**4700 Goshen Rd,
Fort Wayne IN, 46803
Big C Lumber
Project No. 25023**

ADDENDUM NO. 1

June 05, 2026

The following items are revisions, clarifications and additions to the original drawings and project manual for the above referenced project.

STORM PLAN

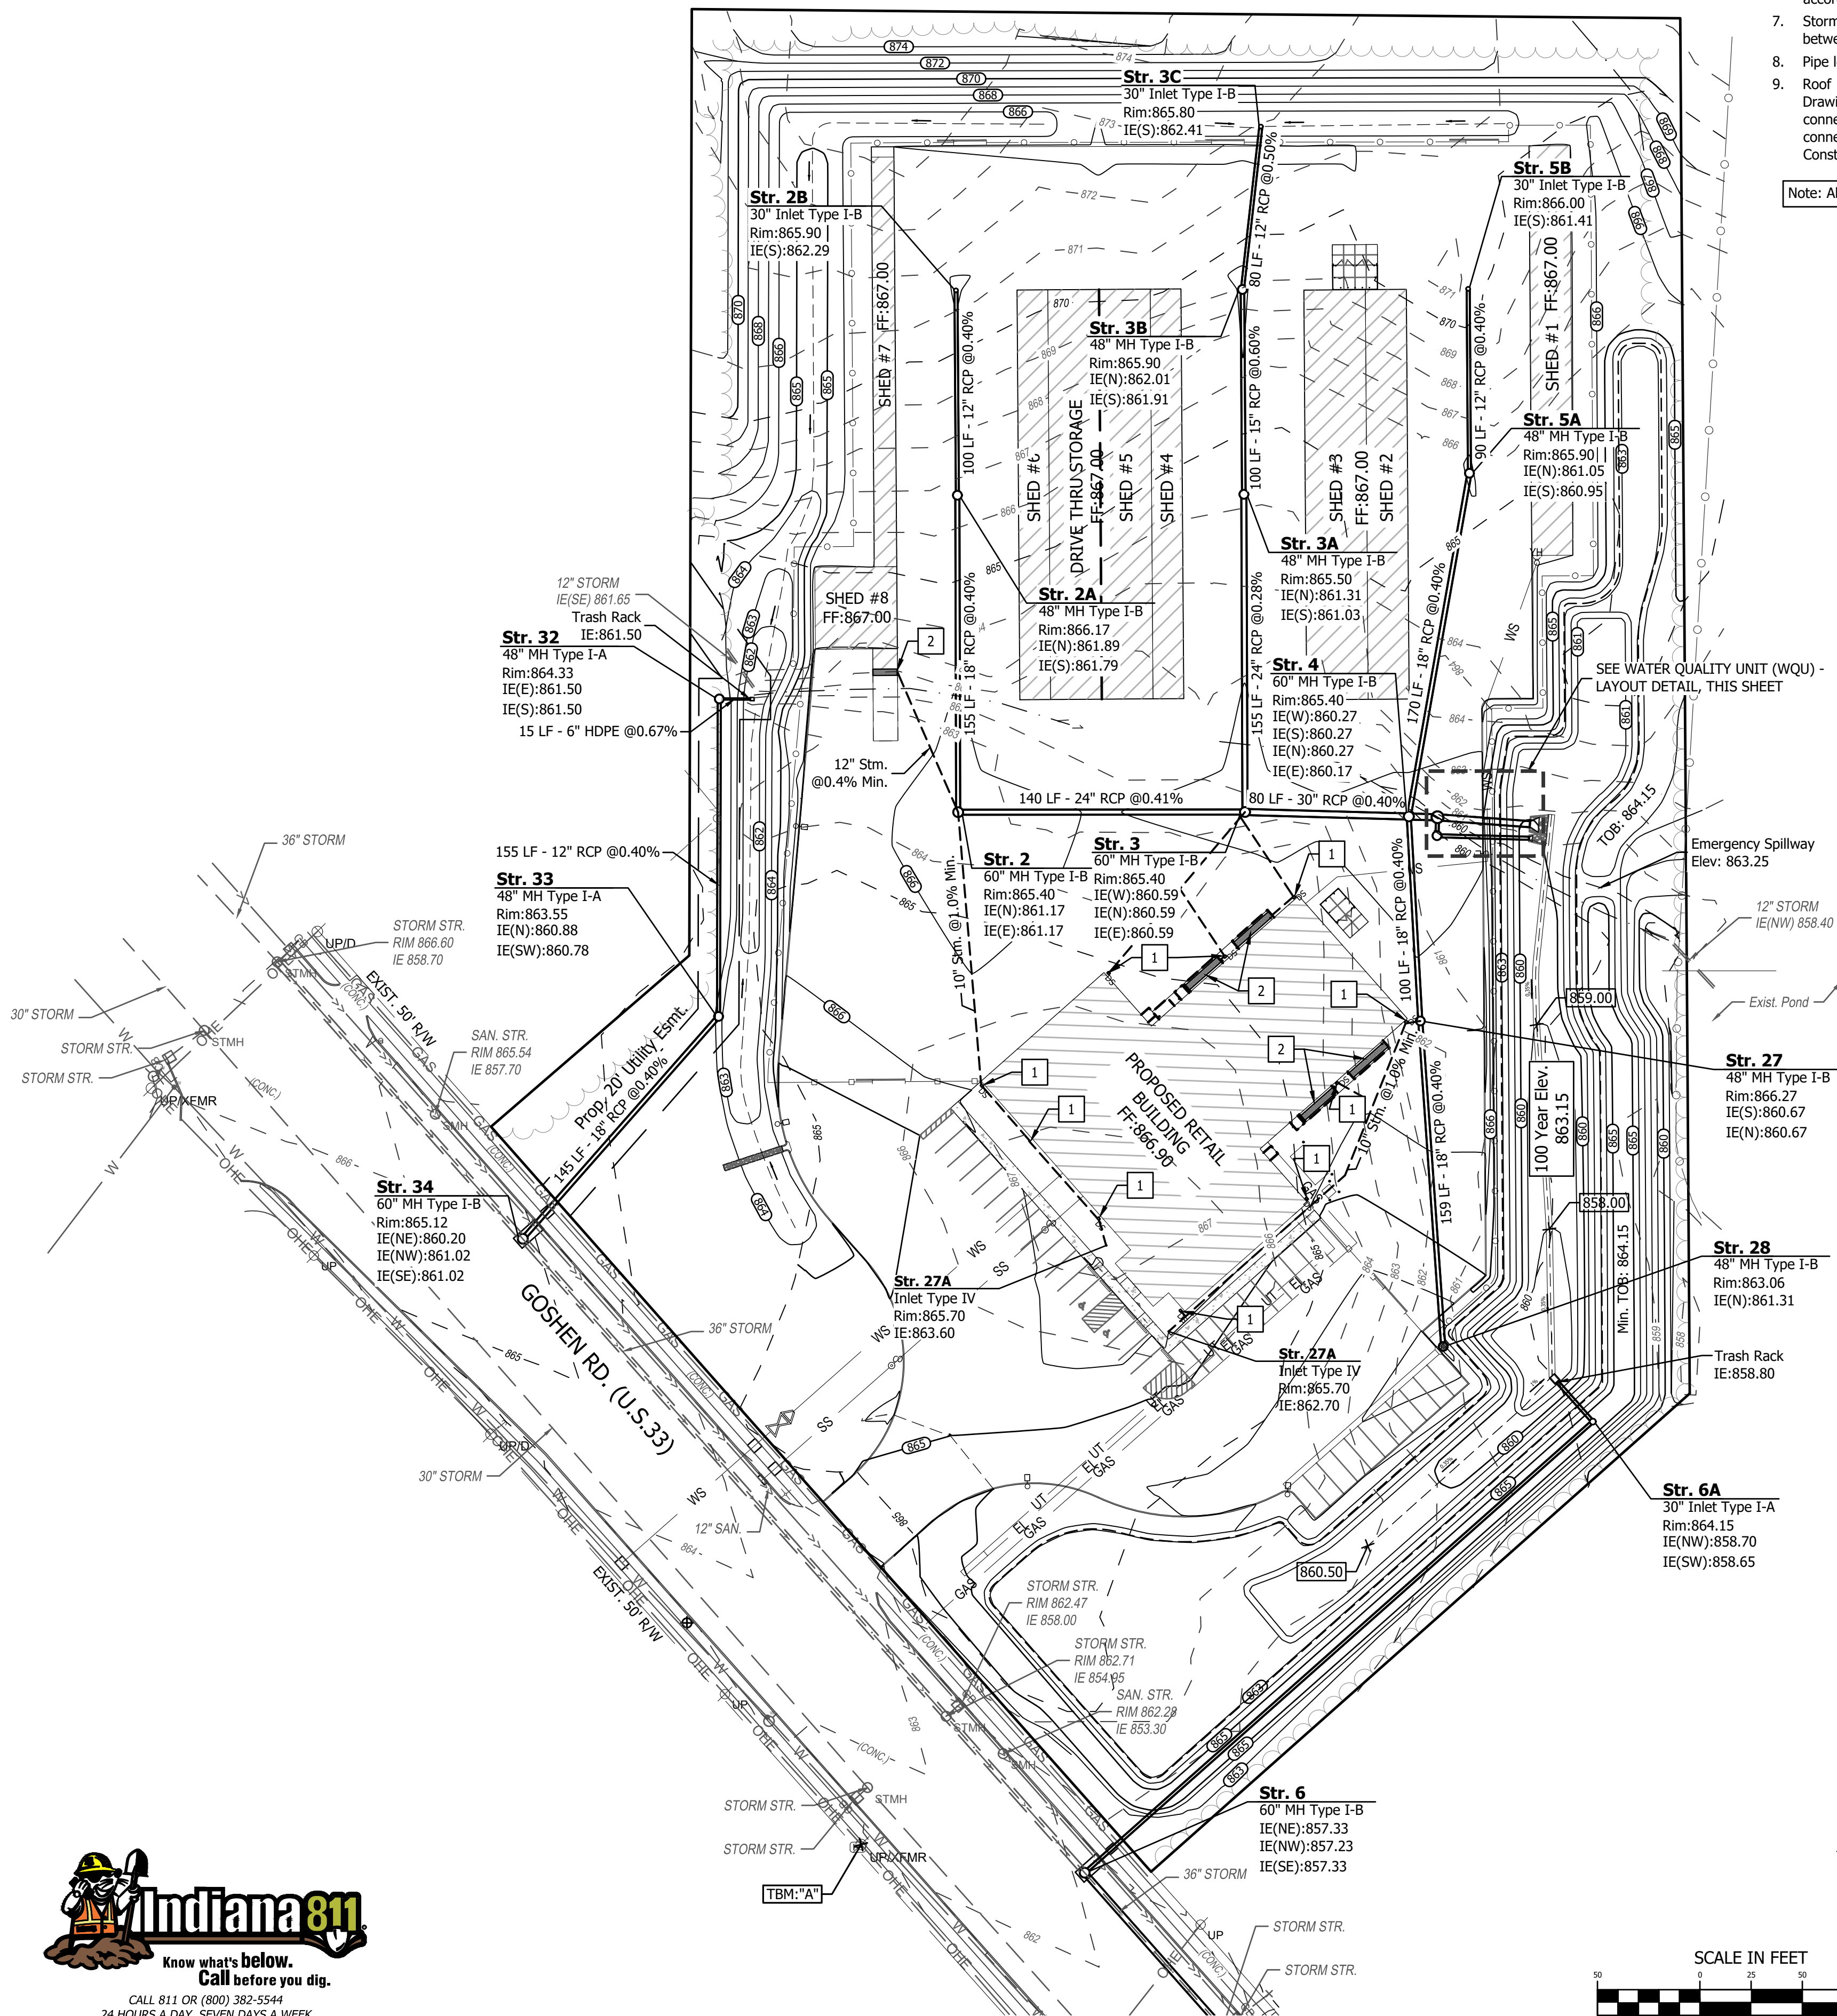
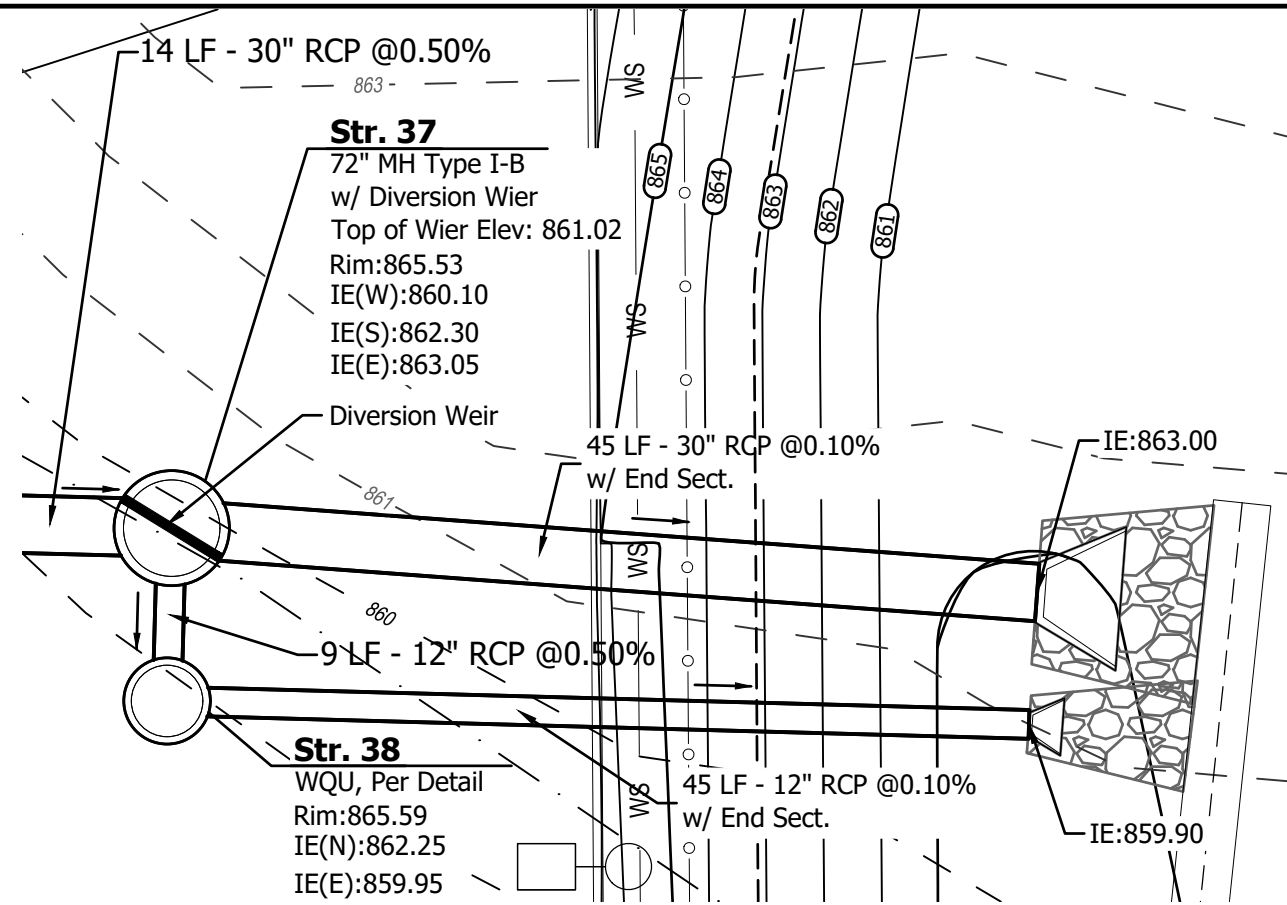
1. Structure 2A invert elevation south to be 861.79,
2. All hard-surface elevations to be raised approximately 0.4', including top of rims, pavement, FFE, etc.,

3. Invert elevations of pipe, basin elevations, 100-year overflow path out of basin, and other elements and elevations of stormwater system (excluding rim elevations) to remain as shown on design,
4. Additional mounding of topsoil on southeast corner, northern edge, northwest corner and the southwest corner will take place,
5. The drawing showing these changes will be issued Monday morning, June 8, 2026.
